CENPD 282-NP-A Volume 4 and Responses to Questions

CENTS CODE

# CENTS Code Verification for the Non-LOCA Analysis of the Westinghouse-Type Plants

Response to NRC
Request for Additional Information
on Volume 4 of CENTS Topical Report

Figure 1. CENTS Model of a Westinghouse Type Three-Loop PWR

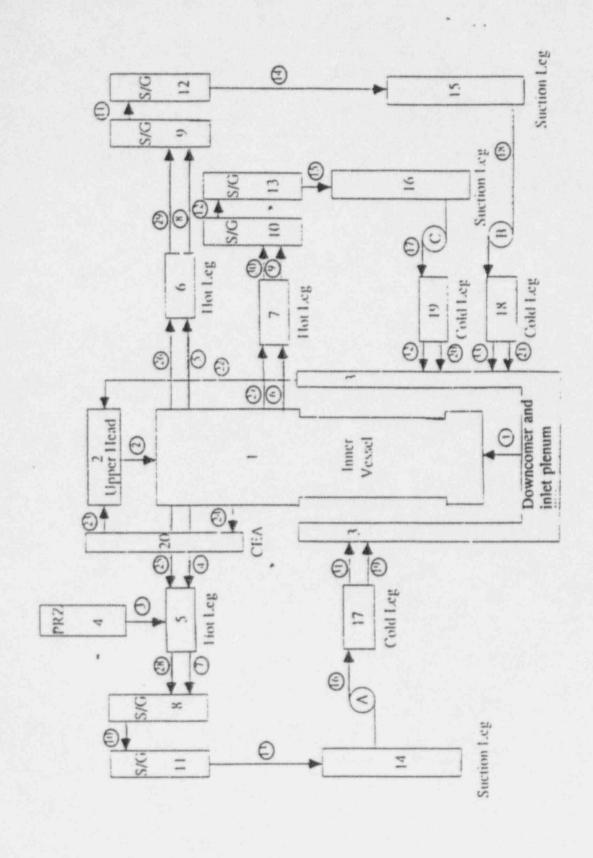
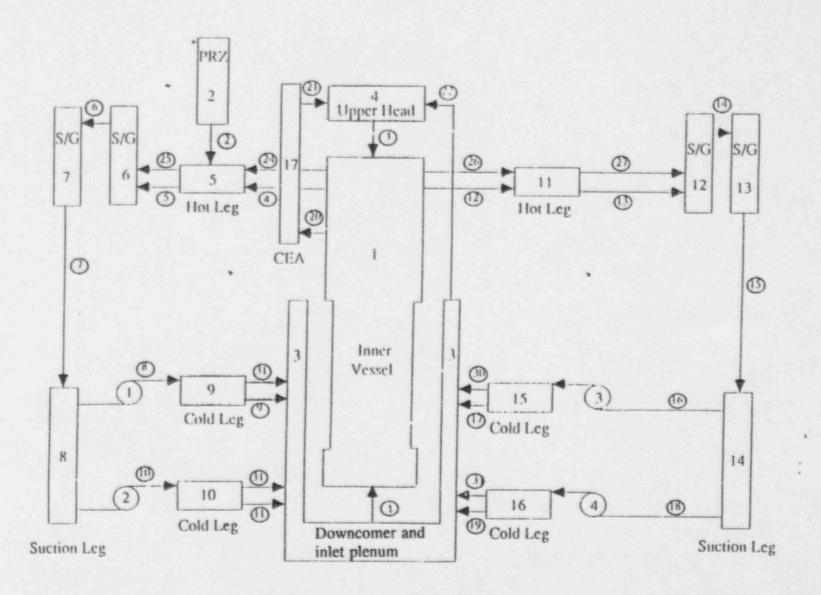
Discuss and provide the basis for any changes made to the CENTS code (relative to the version employed in the Volume-3 "ABB-CE plant benchmarking) in order to perform the Westinghouse plant analyses of Volume-4.

Figure 1 shows the nodalization used for the Westinghouse type plant. Figure 2 shows the nodalization used for the ABB-CE type plant. As shown in these figures, equivalent nodalization was used.
